Attachment B1

Selected Drawings

PROJECT
2235 BILLYARD 21C
DRAWN SENIOR QA APP'D
MP CM WS

DWG TITLE
LEGEND, DRAWING LIST, SITE MAP
DWG NO REV
DA000 J

1 O B01 + B L02

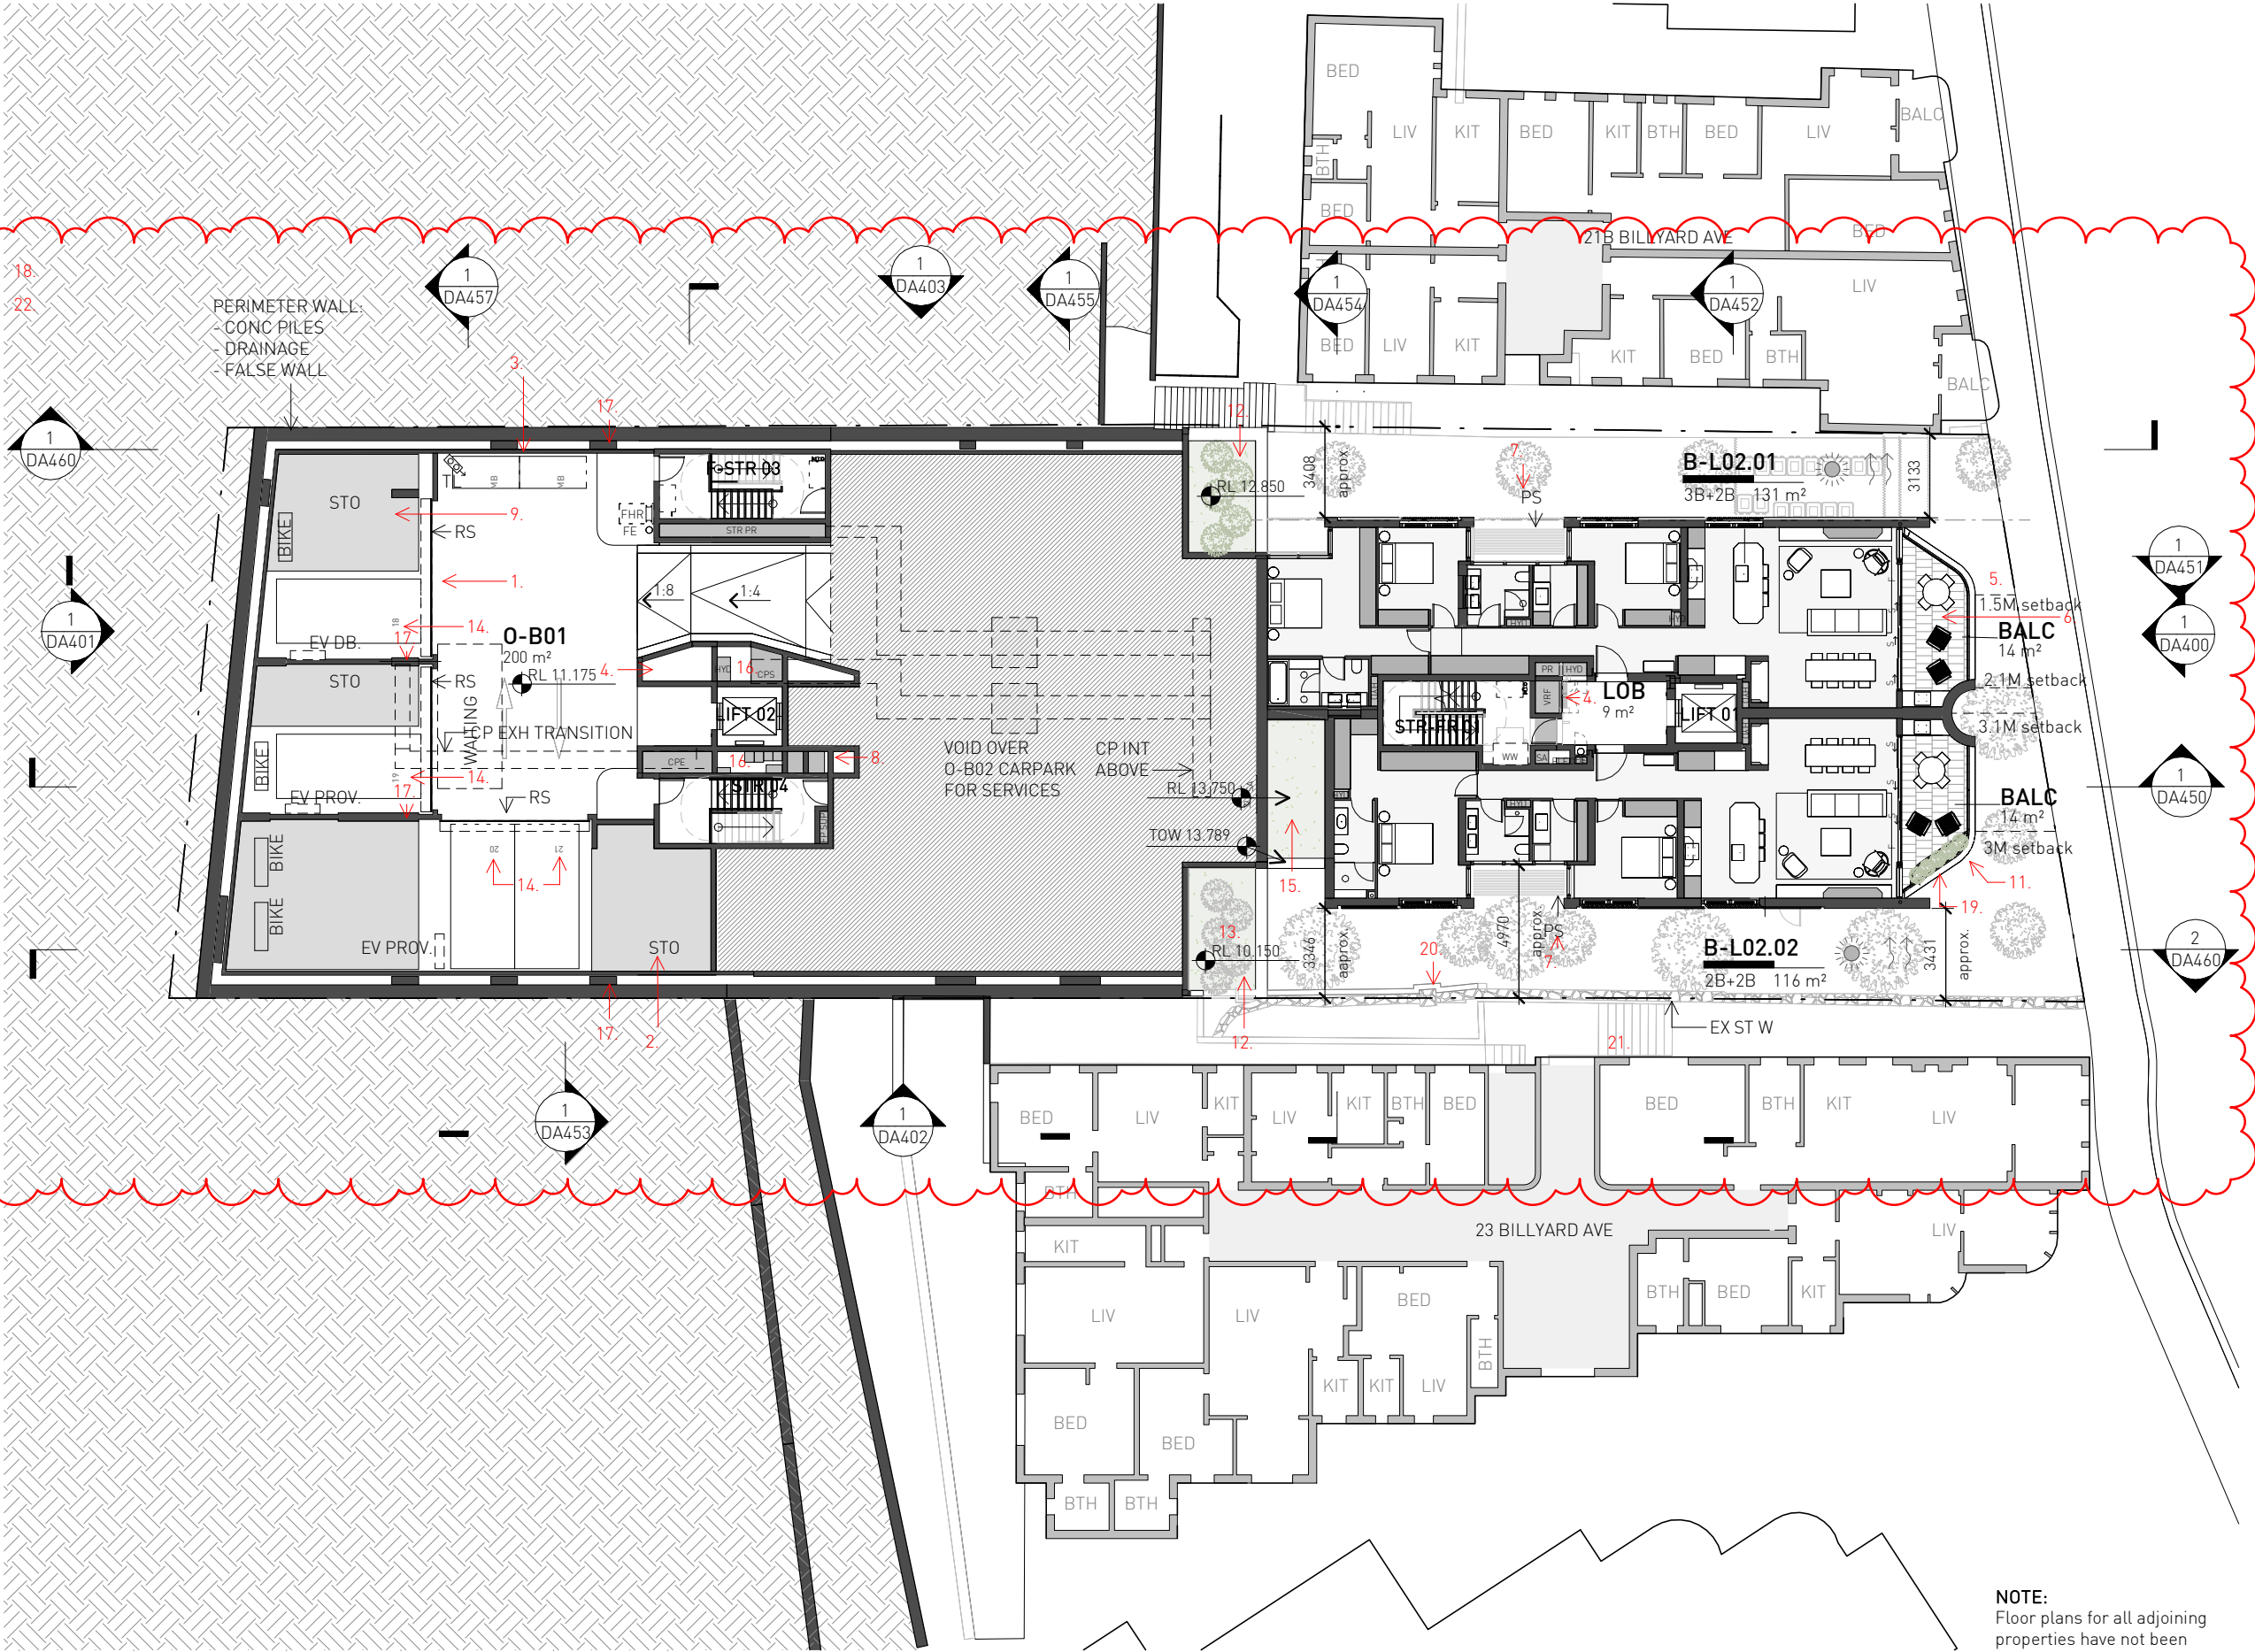
1. O-B01 parking layout revised. Roller shutter garage enclosure shown. Bike spaces allocated in garages.
2. Additional storage added to garage 22.
3. Motorbike spaces relocated to O-B01.
4. Waste Chute removed in both buildings.
5. Risers revised.
6. Billyard front setback increased by 1m.
7. Billyard balconies depth decreased to 2.4m as a minimum to maintain min. depth of living areas after increasing street setback.
8. Horizontal privacy screen added to building indents.
9. Carpark EXH fans relocated from roof.
10. Storage added to garages.
11. Billyard building footprint reduced by 400mm.
12. Balconies splayed.
13. Planter area dropped.

- DA ISSUE 07:
13. Eastern planter area further dropped to O-B02 level.
14. Garage no.18 adjacent to the eastern planter removed on level O-B02. Spaces on level O-B01 renumbered accordingly.
15. Bedroom in unit B-L02.02 removed. Planter added.
16. Services areas adjusted.
17. Structural elements adjusted.
18. Structural elements, service risers, windows position, apartment layouts updated.

- DA ISSUE 08:
19. Planter added to eastern balcony for visual privacy.
20. New retaining wall added and deep soil adjusted.
21. Graphic representation of neighbouring properties shown.

- DA ISSUE 09:
22. Detailing of services, structural elements & perimeter walls shown.

DWG TITLE
0 GF + B RF
DWG NO
DA106
REV
J

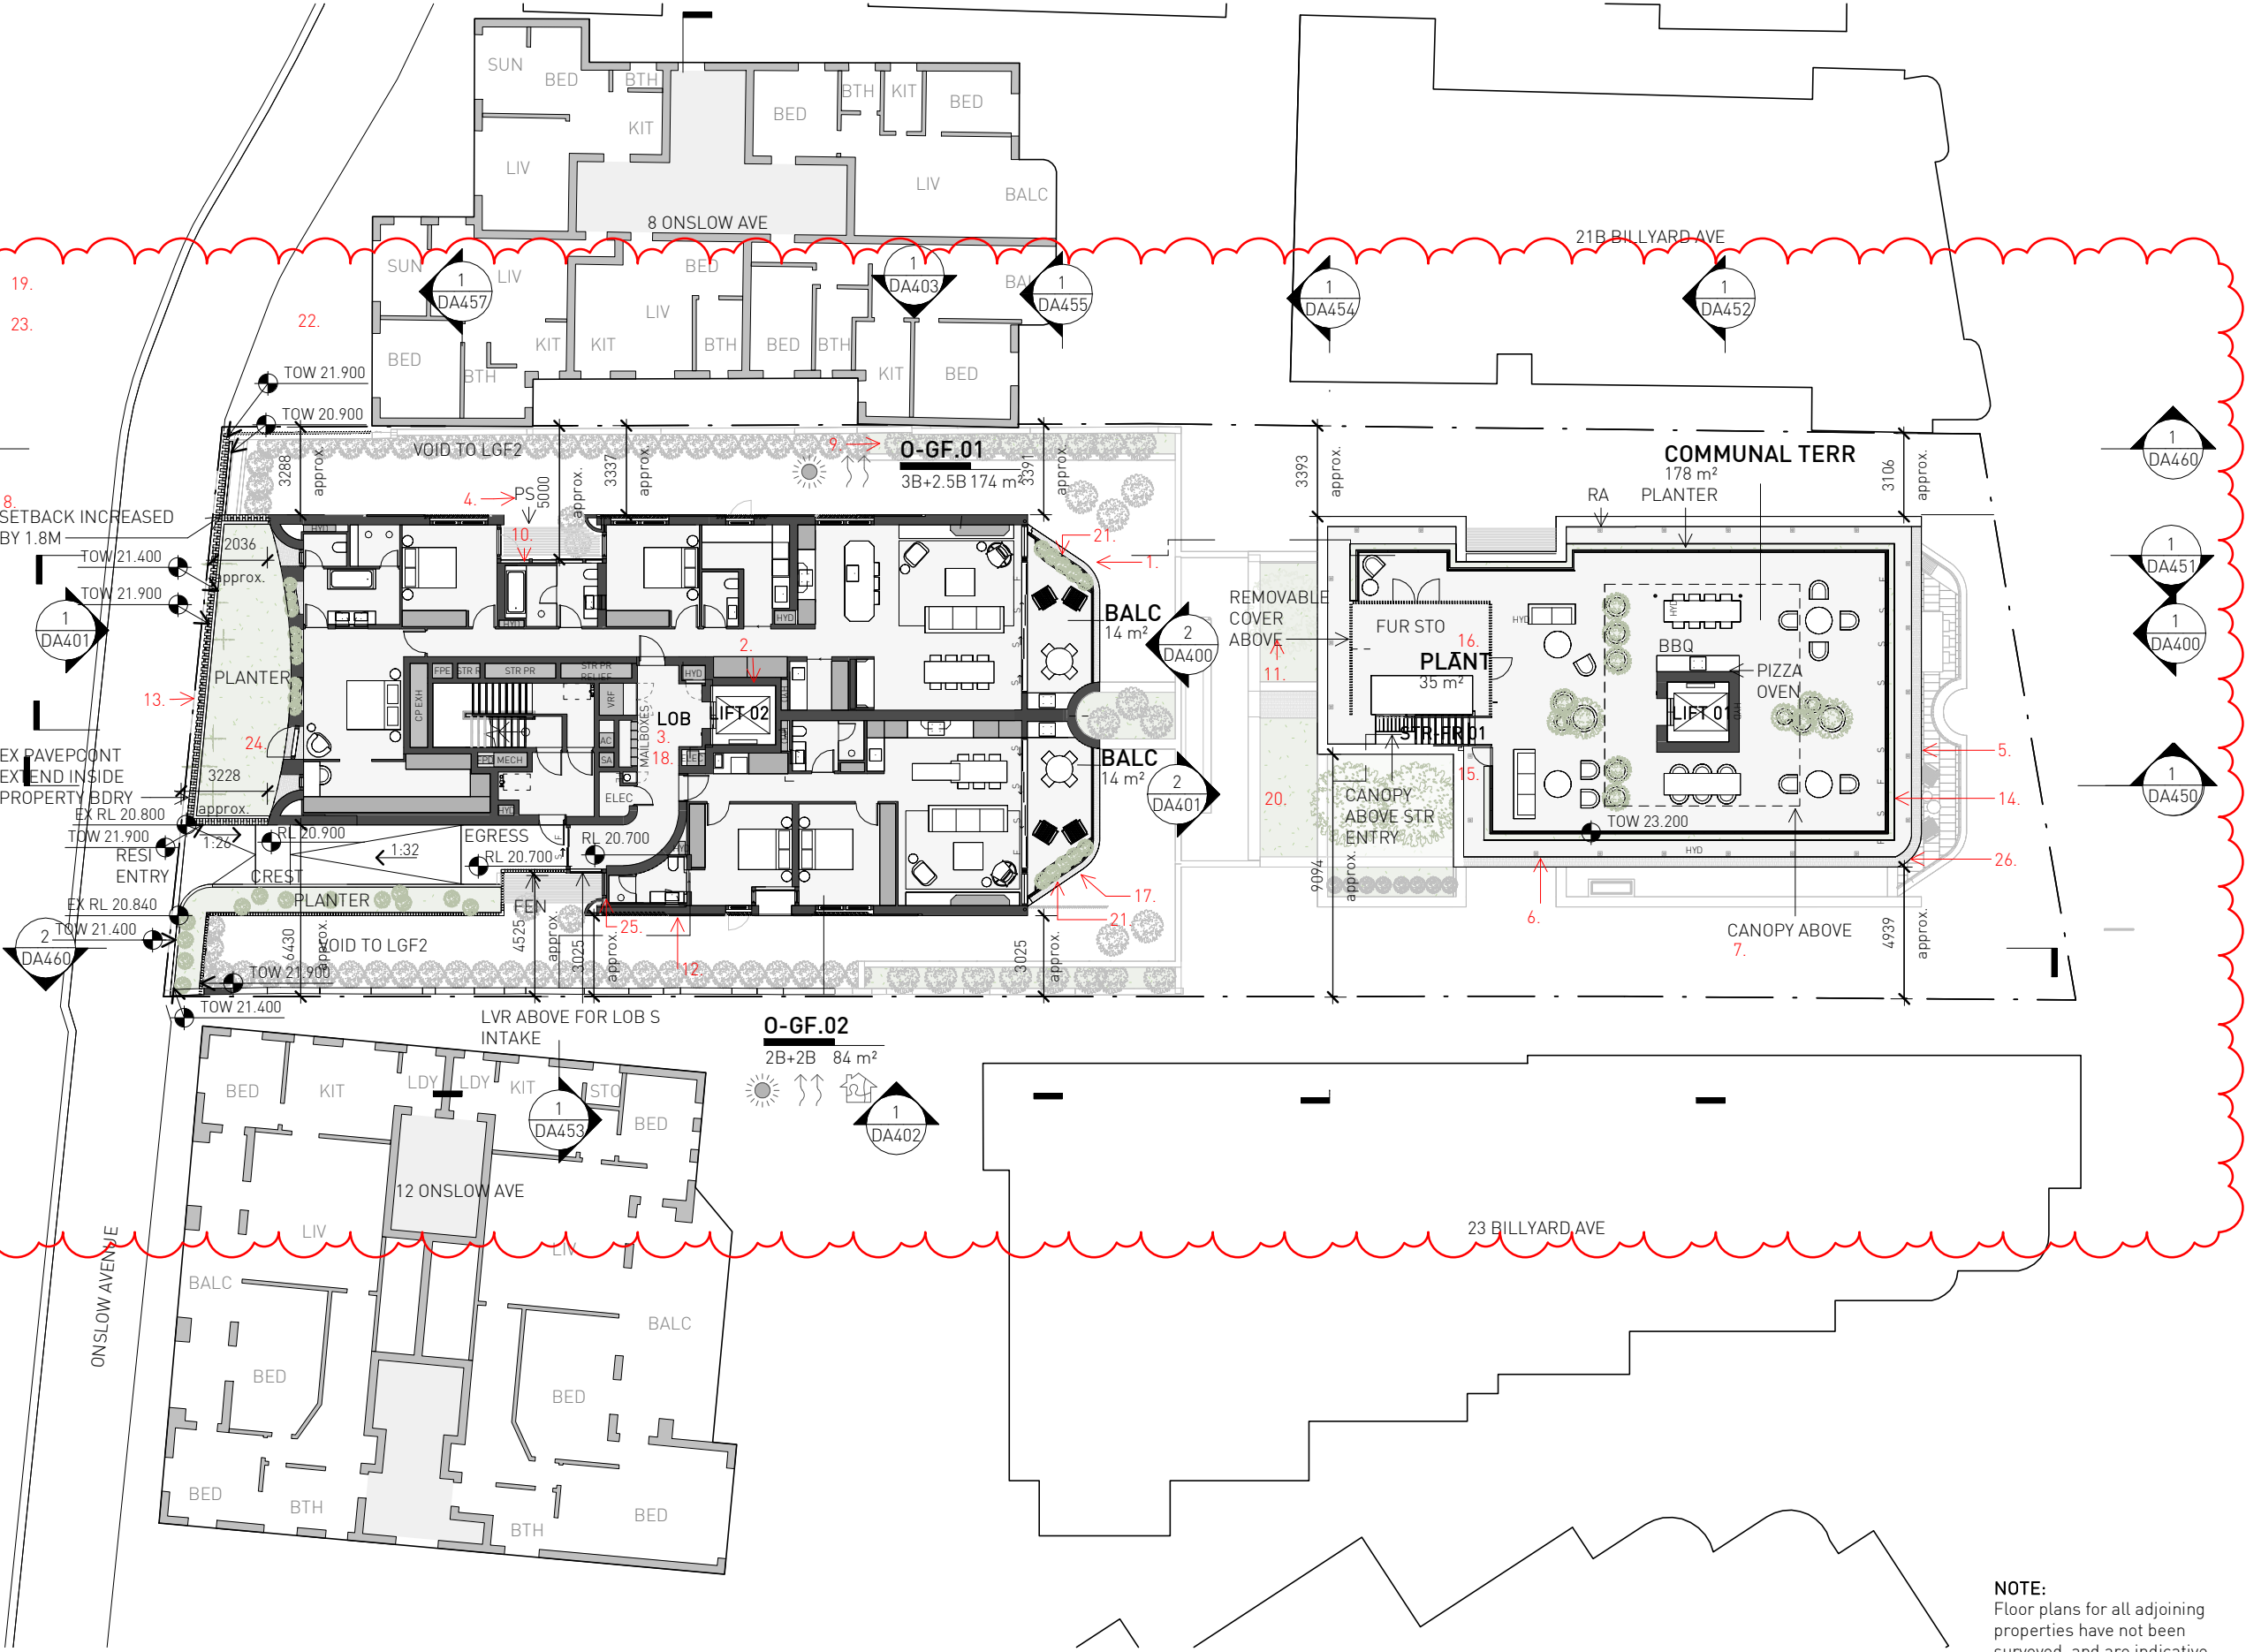
1. N-W Onslow balcony straightened not to exceed height plane demarcation line. Balcony size adjusted to 2.4m.
 2. Core length decreased, risers revised.

3. Waste Chute removed in both buildings. Risers revised.
 4. Horizontal privacy screen added to building indents.
 5. Billyard top edge pushed back by 300mm, leaving 900mm overhang over L04 balcony.

6. Billyard Rooftop area allocated to communal open space. Private Penthouse Terrace removed.
 7. Shading structure added.
 8. Onslow front setback increased by 1.8m.

9. Two units combined into one O-GF.01
 10. Facade adjusted to increase bathroom size.
 11. Plant enclosed by louvered panels. Stair opened to minimize height plane exceedance.

12. Additional screen.
 13. N BK FEN added.
 14. Planters and glass BAL added around B RF perimeter.
 15. Anchor points & Maintenance gate added to B-RF to access planters.

16. Outdoor Furniture storage added.
 17. Balconies splayed.
- DA ISSUE 07:
18. Mailboxes shown.
 19. Structural elements, service risers, windows position, apartment layouts updated.

20. Back of Billyard form & planters adjusted for solar compliancy.

- DA ISSUE 08:
21. Planter added to eastern and western balconies for visual privacy.
 22. Graphic representation of neighbouring properties shown.

- DA ISSUE 09
23. Detailing of services, structural elements & perimeter walls, also including:
 24. Door added.
 25. Solid wall behind glass.
 26. Roof line adjusted to curve.
